UNITED STATES PATENT AND TRADEMARK OFFICE

APPLICATION NO.	FILING DATE	FIRST NAMED INVENTOR	ATTORNEY DOCKET NO.	CONFIRMATION NO.
10/551,289	08/21/2006	Debbie Stevens-Wright	B1075.71018US01	1531

Office Action Summary	Application No. 10/551,289	Applicant(s) STEVENS-WRIGHT, DEBBIE	
	Examiner AMANDA SCOTT	Art Unit 3739

DETAILED ACTION

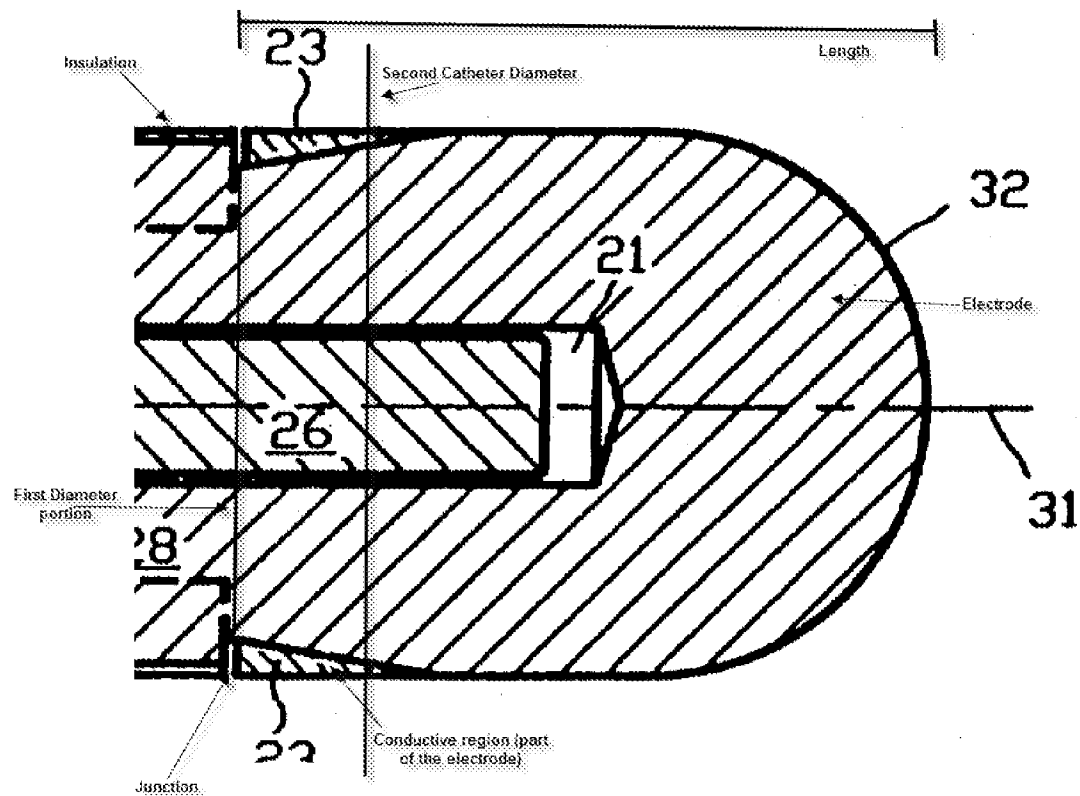
4. **Regarding claims 1 and 7**, Langberg discloses a catheter comprising: a catheter shaft having a distal end, the distal end of the catheter shaft having an insulating material (24) and a diameter; and an ablation electrode(28) forming a junction

with the distal end of the shaft, the ablation electrode having an exposed surface; wherein, extending from the junction, the exposed electrode surface has a first diameter portion with a first diameter that is smaller than the diameter of the distal end of the shaft, the first diameter portion forming an angle with the insulating material; and wherein the exposed electrode surface has a second diameter portion with a second diameter that is larger than the first diameter of the first diameter portion, the second diameter portion having a largest diameter that is smaller than a length of the second diameter portion; and wherein the exposed electrode surface further comprises a transition face extending from the first diameter portion to the second diameter portion, the transition face forming an approximately ninety degree angle with the first diameter portion (view figure 4 and figure below) .

5. **Regarding claim 3**, Langberg discloses the catheter according to claim 1, wherein the insulating material, the first diameter portion and the transition face form a recessed region that allows blood to flow across the first diameter portion and the transition face when the electrode is placed in a blood flow (when the catheter is placed in the vascular system blood will flow through the recessed region, view figure 4 and figure above, column 3, lines 32-41)).

7. **Regarding claim 9**, Langberg discloses the catheter according to claim 1, wherein the distance from the insulating material to the transition face along the first diameter portion is less than the diameter of the first diameter portion (view figure above and figure 4).

8. **Regarding claim 12**, Langberg discloses the catheter according to claim 3, wherein the recessed region encircles the ablation electrode (view figure above and figure 4).

9. **Regarding claim 13**, Langberg discloses the catheter according to claim 1, wherein a largest diameter of the electrode is no larger than a diameter of the insulating material forming the first sidewall (view figure 4 and figure above).

10. **Regarding claim 14**, Langberg discloses the catheter according to claim 1, wherein the transition face is parallel to a distal end of the catheter shaft (view figure 4 and figure above).

11. **Regarding claim 15**, Langberg discloses the catheter according to claim 1, wherein the first diameter portion and the insulating material form an angle of approximately ninety degrees (view figure 4 and figure above, the angle is shown as a right angle).

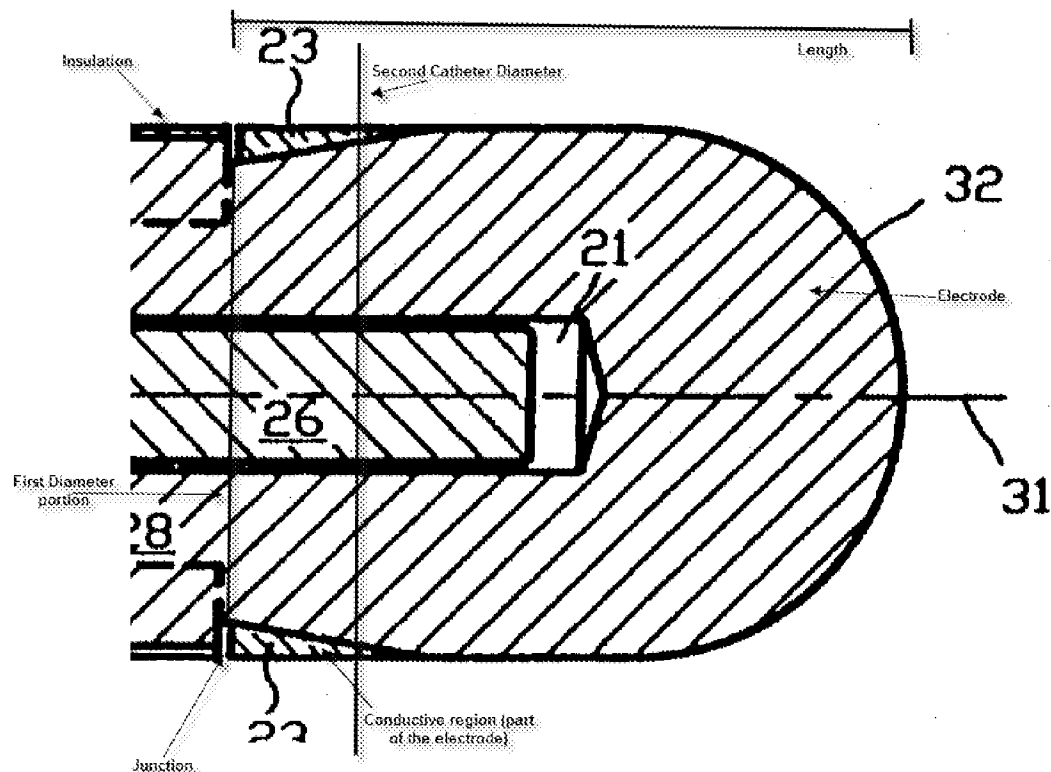
21. **Regarding claim 35**, Langberg discloses providing a catheter shaft (24) with an insulating sheath (28); providing an ablation electrode having a first diameter portion with an exposed surface and a second diameter portion with an exposed surface, a transition face between the first and second diameter portions, and the second diameter portion having a length that is larger than a largest diameter of the second diameter portion; and attaching the electrode to the shaft, such that: the first diameter portion of the electrode forms a junction with the shaft, and the first diameter portion has a diameter that is smaller than a diameter of the insulating sheath at the junction of the electrode and the shaft; each of the transition face and the sheath forms a sidewall of a channel and the first diameter portion of the electrode forms a base of the channel the transition face forms an approximately ninety degree angle with the channel base (view figure 4 and figure below).

22. Langberg fails to explicitly disclose a method of manufacture; however, Langberg does disclose all of the claimed parts which are manufactured to be within the scope of the claim. It would have been obvious to one having ordinary skill in the catheter art to take the components as show in figure 4 and manufacture them to have a recessed portion with an exposed electrode surface as well as an insulation sheath. Doing so would allow the user to have a catheter manufactured that can be used within the vasculature of a patient to increase cooling of the tip by having blood or fluid flow through the exposed channel.

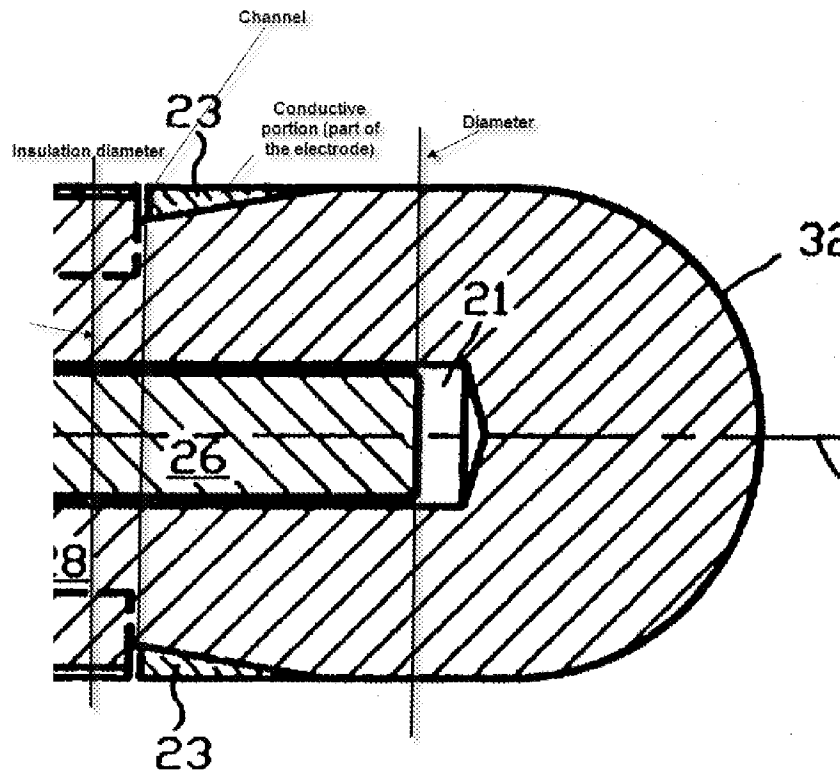
32. **Regarding claim 27**, Langberg discloses the catheter according to claim 19, wherein the distance from the first sidewall to the second sidewall along the base is less than a diameter of the first diameter portion (view figure above (claim 1) and figure 4).

33. **Regarding claim 29**, Langberg discloses the catheter according to claim 19, wherein the channel encircles the ablation electrode (view figure above and figure 4).

34. **Regarding claim 30**, Langberg discloses the catheter according to claim 19, wherein a largest diameter of the electrode is no larger than a diameter of the insulating material forming the first sidewall (view figure 4 and figure above).

35. **Regarding claims 26, 28, and 31**, Langberg discloses the catheter according to claim 19, but fails to disclose the distance from the first sidewall to the second sidewall along the base is more than 0.3 millimeters, the second sidewall extends at least 0.3 millimeters toward a center longitudinal axis of the electrode from an outer surface of the electrode, or the ablation electrode is approximately four millimeters in length.

36. However, Langberg does disclose a catheter with an ablation tip electrode having a channel with a transition face. Langberg does not explicitly disclose the lengths or sizes of the transition faces or sidewalls of the junction. Applicant does not give a criticality to any of the specified sizes or distances. It would have been obvious matter of design choice to someone in the catheter ablation art to choose different sizes, depths or distances to the junction, since it is well known in the ablation art to have recessed regions for cooling of the electrode tip during use. In re Rose, 105 USPQ 237 (CCPA 1955). MPEP 2144.04
